Report – Takitimu North Link Stage 2 Specimen Design – Downstream Flood Effects Investigation

Review by Graham Macky, Macky Fluvial Consulting Ltd

Included are the response from the designer and subsequent comments from the reviewer

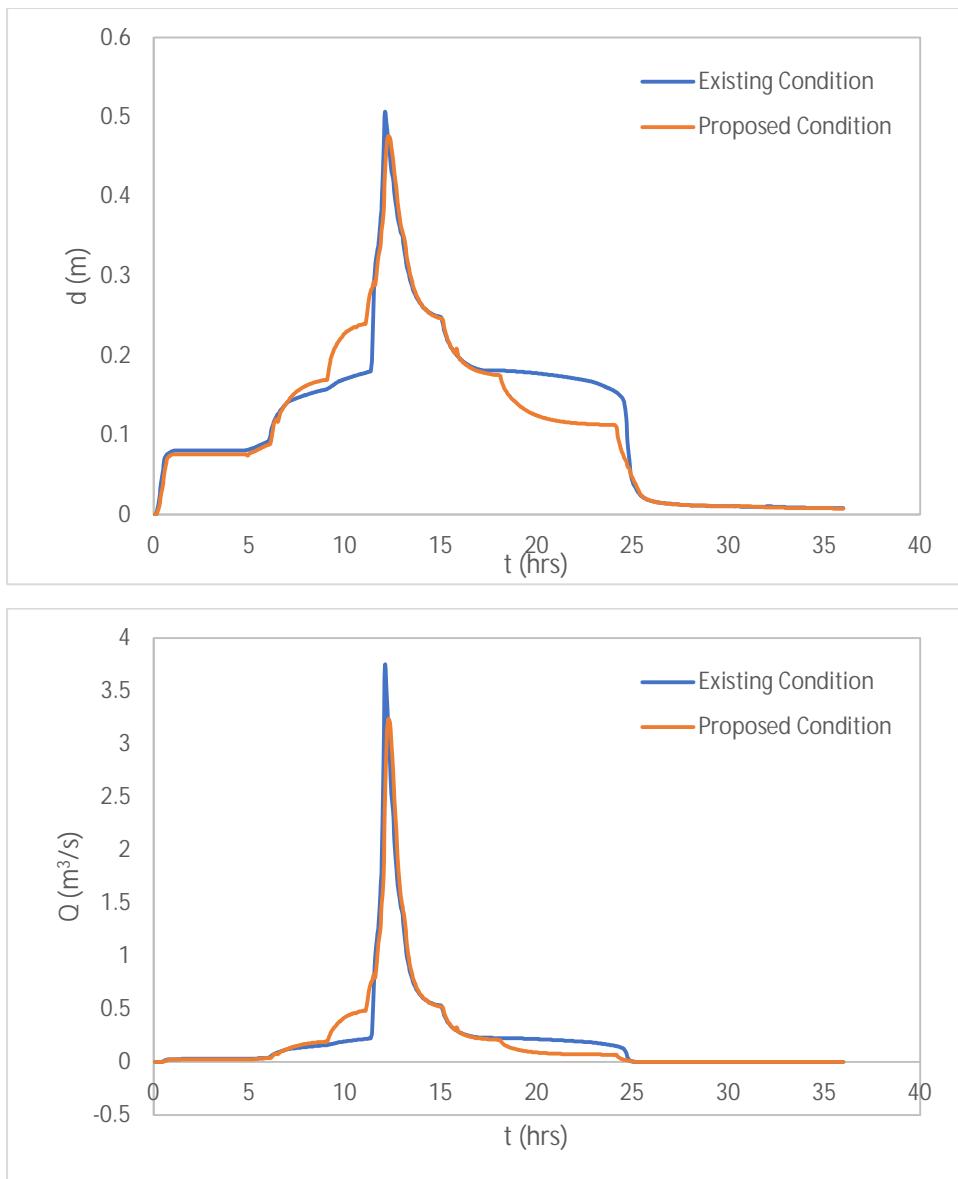
Comment Reviewer: 2.2 p8 - I'm a bit puzzled here, not by the actual works proposed but by the discussion of whether there are any adverse effects here from the project. The effect on peak flow and water level of a larger culvert OMK-60 may extend downstream of SH-270 because that culvert is also being upgraded. Pre- and post-development flow hydrographs and water level profiles would be helpful both for me and for later readers.

Response Reviewer: I presume (1) that the 2nd of these graphs in fact shows flow rate through + over OMK60 and (2) that the roadway will be raised. I think your report should include this flow hydrograph.

However (and I may be missing something basic here) despite your explanation I can't see why the lower flow gives a higher water level immediately downstream.

Response Designer: The water depth and the flow for the existing condition and proposed condition during the 100yr ARI design storm including climate change are presented in the figures below. Note that the peak flow rate downstream of the culvert is higher in the existing condition than in the proposed condition. In the existing condition, overtopping of the road begins before the time of peak rainfall intensity. Hence at the time of peak rainfall intensity, the flow through the culvert (small) plus the flow across the road (large) is equal to the runoff rate. In the proposed condition, flow only goes through the culvert. There is no overtopping. At peak rainfall intensity, the culvert does act as a flow control structure, hence the peak flow rate is slightly smaller than the peak runoff rate. Despite the smaller flow rate, the peak flow depth is slightly higher in the proposed condition. This is because the higher peak flow rate in the existing condition also results in higher peak velocities (2.2m/s versus 1.7m/s) as the road overtops.

Response Designer: Apologies for the confusion. The label on the y-axis of the 2nd graph was indeed wrong and should have been the flow rate immediately downstream of the culvert. In addition, there was an error in the roughness applied to the downstream section of the proposed condition model. The updated results are shown above, confirming that the lower flow rate also results in a lower flow depth.

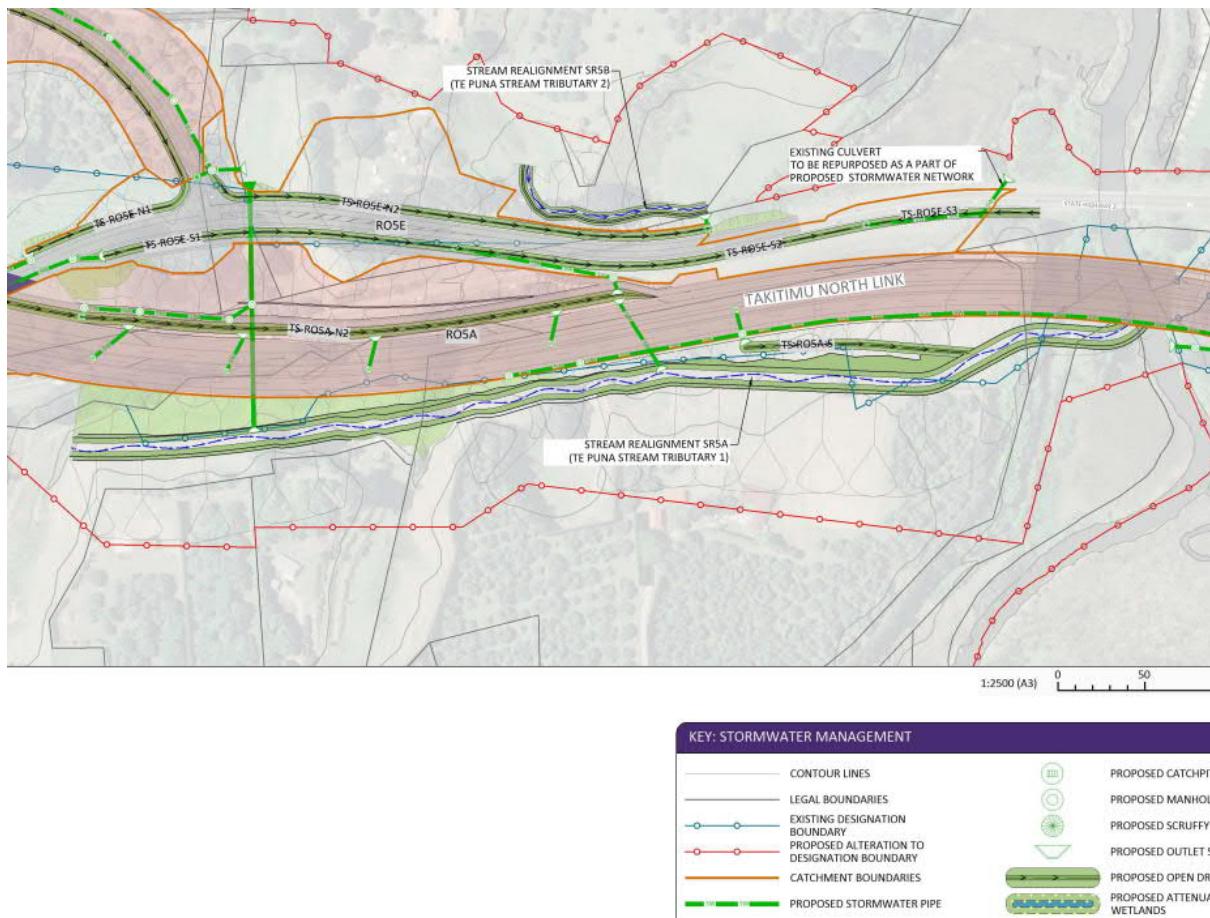
Can you indicate on Figure 6 the small sub-catchment that will still flow through the culvert, or refer to a plan that does show that?

Response Designer: Text has been updated with additional words and links to relevant section in the "Takitimu North Link Stage 2 – Specimen Design – Stormwater Management" report, Appendix B, drawing 144702-00-2216. Please note that in the last version of this report that was forwarded to you, this drawing did not show the correct proposed connection between the swales next to SH2 and culvert. The proposed pipe is to connect a proposed treatment swale alongside SH2 with the existing culvert from the side. The upstream end of the existing culvert is to be blocked off. This has now been updated. A snip of the updated drawing is shown below.

In addition, Figure 6 has been updated to include a representation of the existing culvert that was missing from the earlier figure.

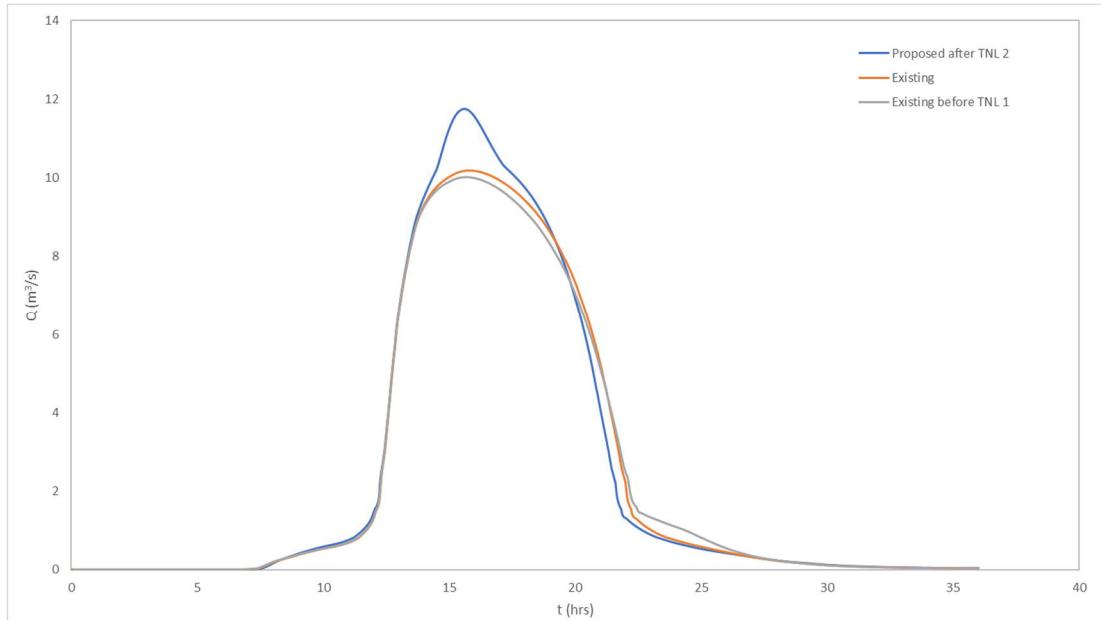
Comment Reviewer: P23 - If there were any concern about the project causing channel erosion just upstream of the coastal marine area, then you'd also need to model the design rainfall event coinciding with low water.

Response Reviewer: This graph should go into the report, I think, or the 100-year equivalent (or is this information already there as the green lines in Figure 20?). As you say, downstream of the railway we get a minor increase in flow rate, limited to about 5 hours. Thus the downstream effects here are moderate, both for channel stability and for closure of Borell Road.

Response Designer: Because the flow is controlled by the KiwiRail culvert and the KiwiRail embankment does not overtop, changes in the hydrodynamics downstream of the KiwiRail culvert, due to the upsizing of the SH2 culverts are small. The plot of 2-year hydrographs below provides a comparison of the flows under three conditions (existing,

existing after TNL-1, and TNL-2 proposed). The results are based on 2130 climate adjusted rainfall and low tide with no sea level rise.

High tide and sea level rise will increase the tailwater at the downstream end of the stream enough to negate any significant change in velocity within the channel due to the flooding from the harbour. As can be seen in the graph, the small increase in peak discharge in the proposed condition has a short duration and the existing conditions indicate a slightly longer duration within the range of typical channel forming discharges. While some inference could be made around the increase or decrease in potential erosion in the downstream reach of the stream, the effect would be minor regardless.

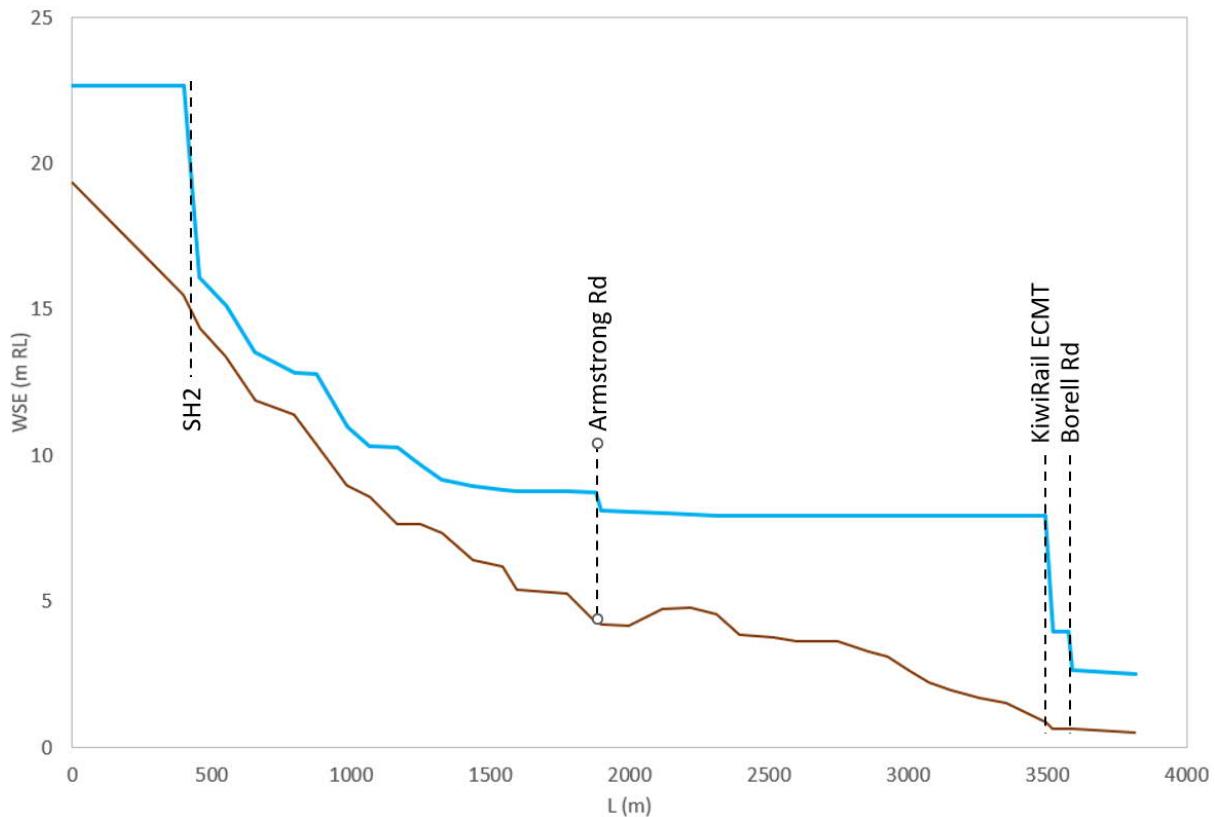
Comment Reviewer: 4.1 5th para: "... the model results suggest that [4 crossings] are major control structures". They no doubt are, but neither Fig 15 nor Table 6 demonstrates this really. Could you add a peak water level profile from upstream of SH2 to the sea? Or instead include in Table 5 water levels downstream of the culverts?

Response Reviewer: The profile is useful! I'm not sure how important it is, but the figure suggests that SH2 and the railway are indeed major control structures, but probably not the other two roads.

Response Designer: The following figure has been added to the text:

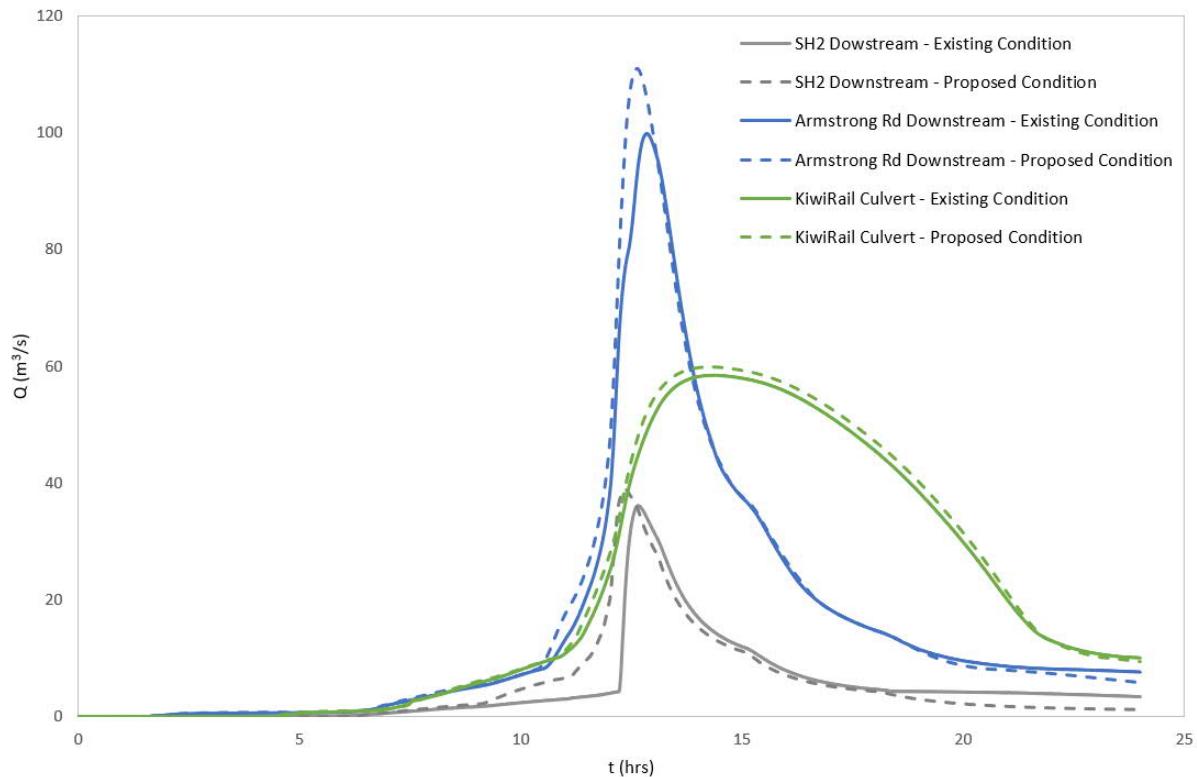
Again, a long profile of peak water levels (existing vs proposed) would be instructive. So would be one or two flow hydrographs (existing and proposed for a particular location plotted together) which would show the existing storage in action.

Response Reviewer: Figure 20 and Tables 5-8 are helpful. I see from Tables 5 and 7 (but not 6 and 8) that flooding of Armstrong Road will be significantly worse. That also implies more frequent flooding in lesser events. However, BoPRC may well note that it's a return to pre-1950s (more or less) and perhaps no more than an inconvenience.

A hydrograph of the flow rates downstream of the three main flow control locations within the catchment, i.e., SH2, Armstrong Rd and KiwiRail culvert, is shown below. It compares the flow rates in the existing and proposed conditions. It confirms the slightly larger peak flow rates (as per Tables 5 and 6). It also highlights that the peaks are delayed in the existing condition as water fills the volume upstream of the SH2 culvert, before overtopping, which results in a very rapid increase in the flow rates downstream of the culvert.
